PRODUCT CHANGE NOTIFICATION

Select Bourns® Power Transient Voltage Suppressor (PTVS) Diodes

Additional Assembly Line, Test Site and Epoxy Material Change

ESD2403

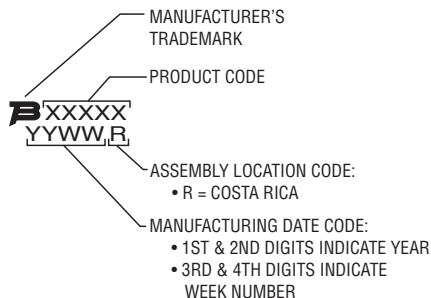
The part marking shown to the left will be used to identify units produced at the additional A/T site. A five-character code is to be used. (4-digit date code + 1 country letter code). The fifth character represents the A/T site code. In this case, the character "R" represents the Costa Rica A/T site. Therefore, although there will be no change to the fit, function, quality and reliability of the parts assembled at the new site, the form will change slightly because of the addition of the assembly location to the part marking.
